Re: Restoration Bay – The Tides

Case Number: Z/LU-14-09-19 Parcel: 33-30-15-00000-240-0100

RFAI Response #1

RESTORATION BAY
PINELLAS COUNTY, FLORIDA
EVELOPMENT MASTER PLA

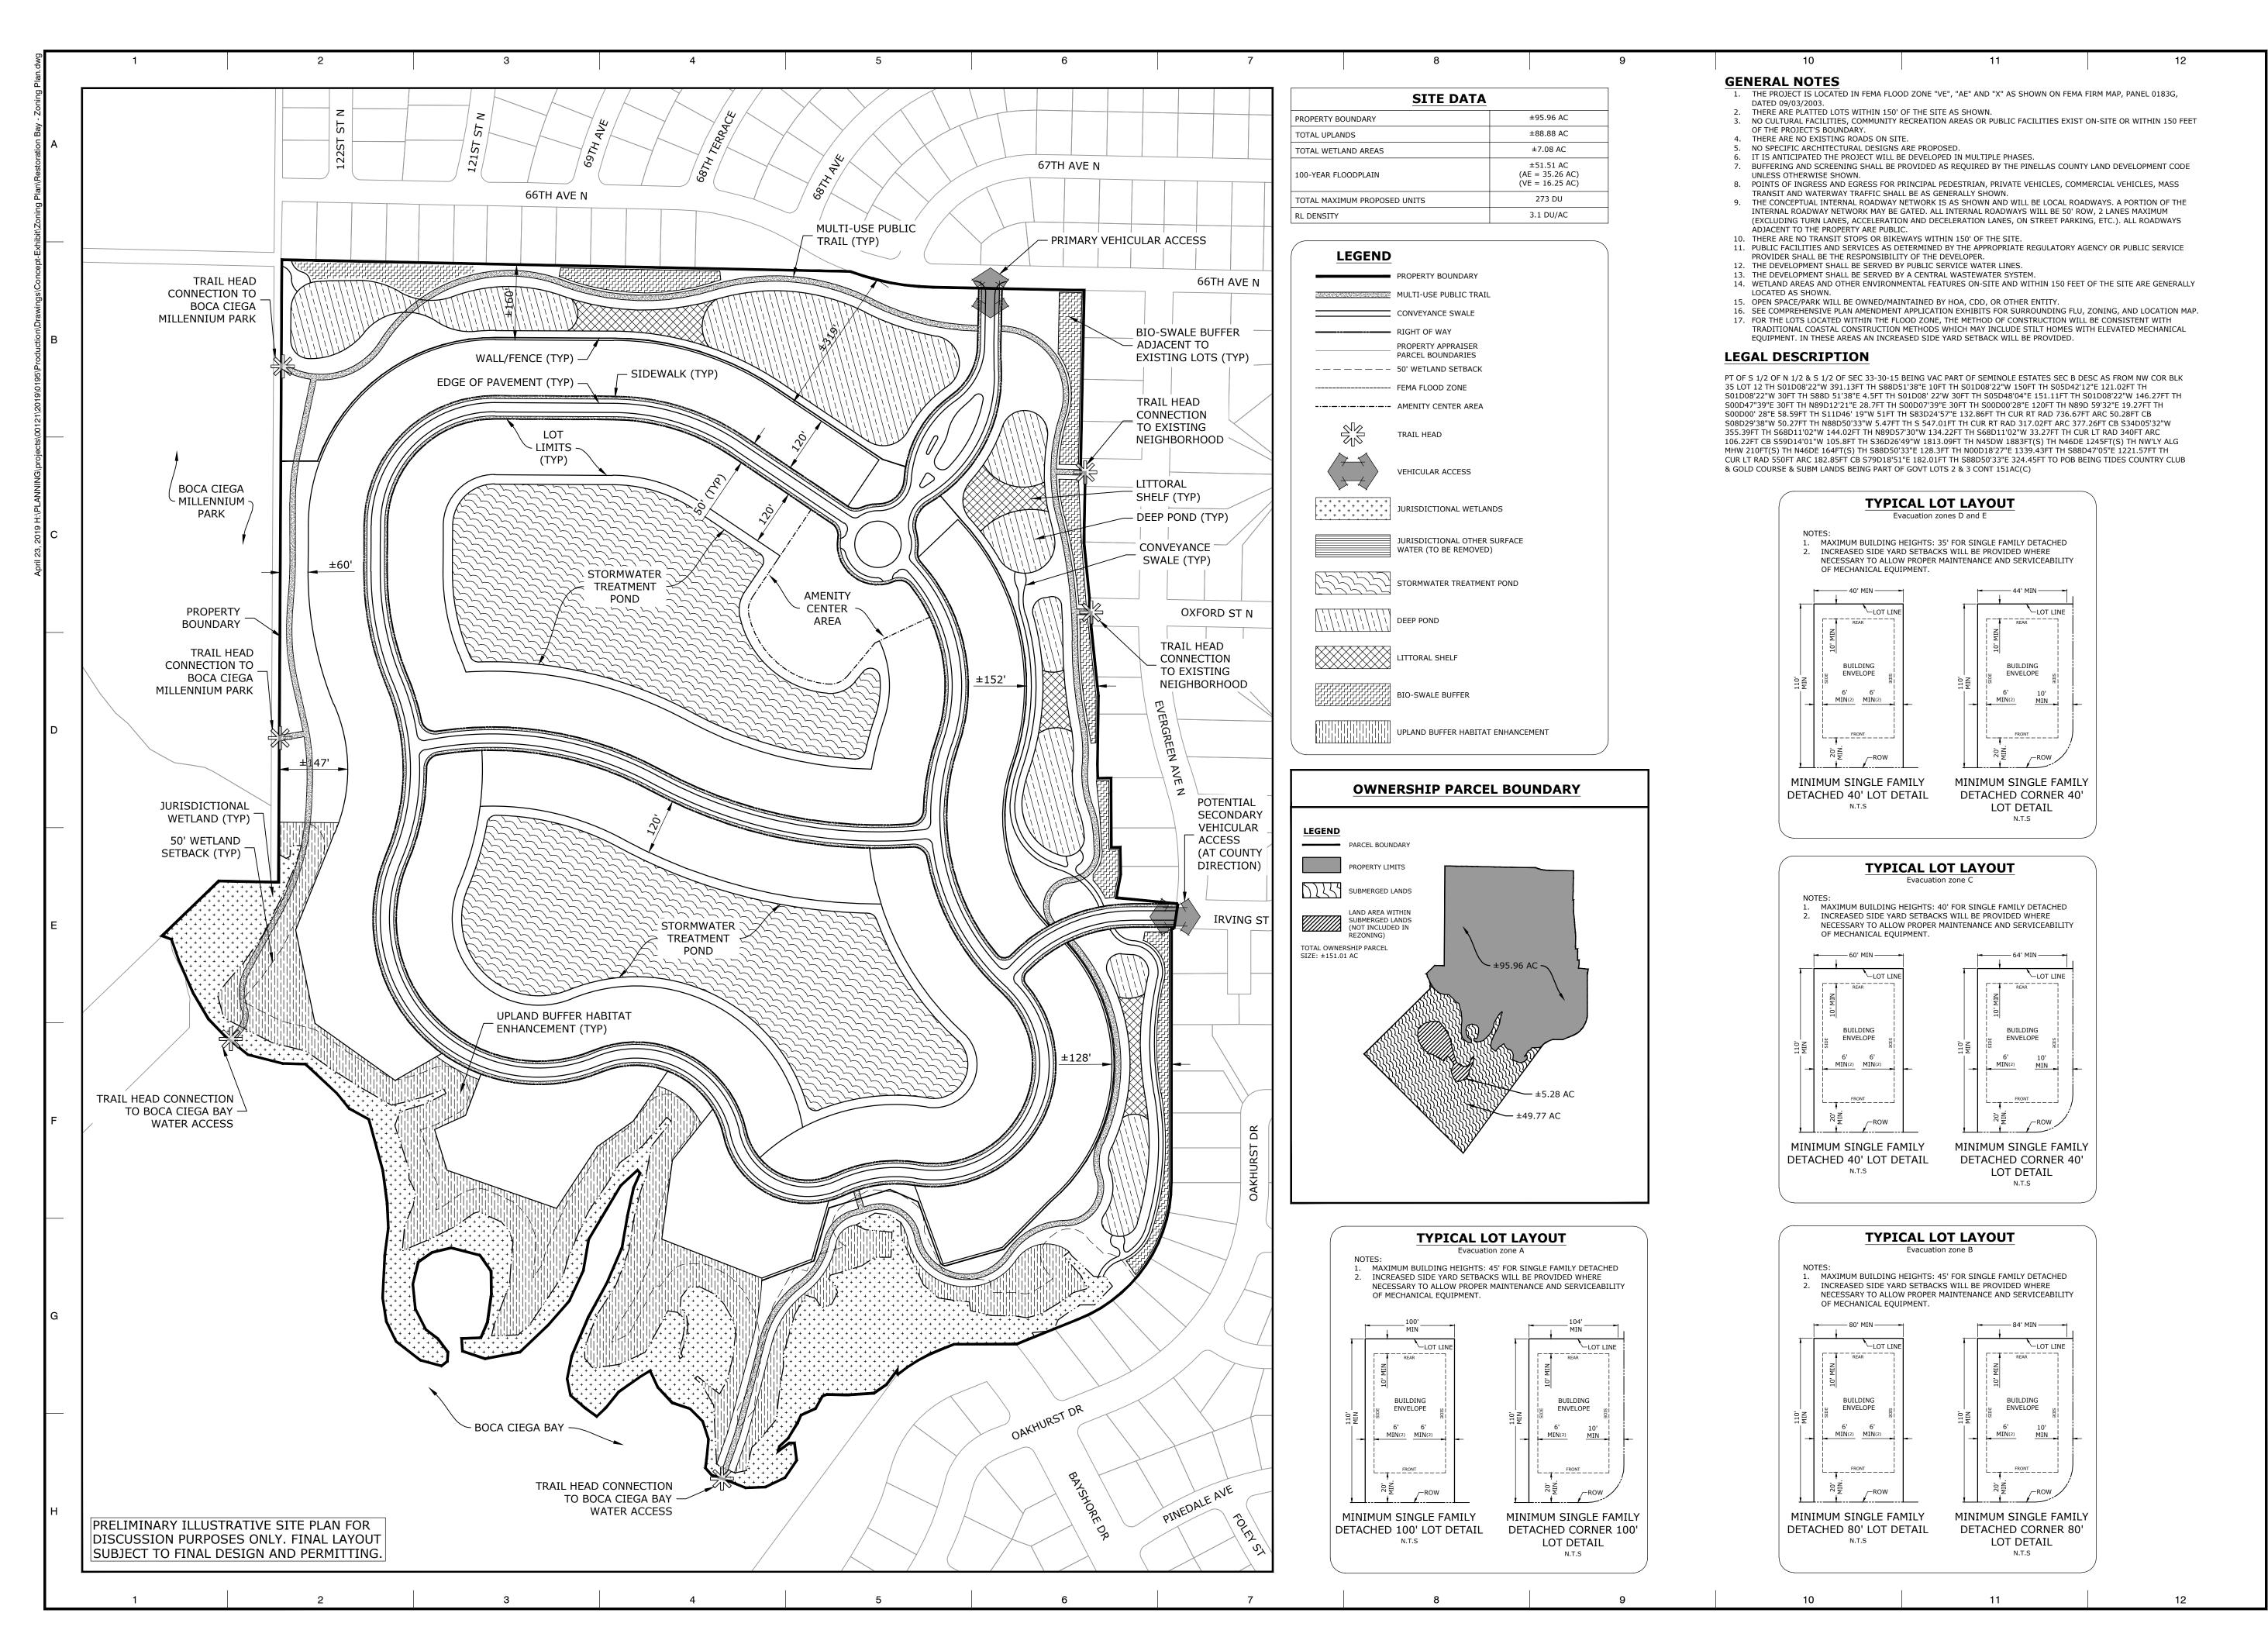
3. The RPD zoning district requires that the district be master planned as a creative, walkable and context-sensitive community that responds to the surrounding land use pattern and preserves unique natural features. Therefore, the Development Master Plan should seek to set aside the more vulnerable areas of the site for preservation/open

space uses. The current design does not achieve this, nor does it evaluate and compensate for the impacts of future sea level rise.

Ardurra Response: Several design elements have been incorporated to further demonstrate that the proposed plan is creative, walkable, and context sensitive and preserves until natural features. Please see the revised RPD District Development Plan which shows 35 acres under conservation easement including the 1.2 mile long multiuse path facilitating public access to the coast not previously possible with the golf course. The conservation easement demonstrates that vulnerable areas have been set aside for preservation and open space uses. We have revised the lot mix to ensure that density is directed away from the coast. Consistent with recent creative design standards adopted by the City of St. Petersburg, we are proposing similar design standards to address wind, storm surge and sea level rise.
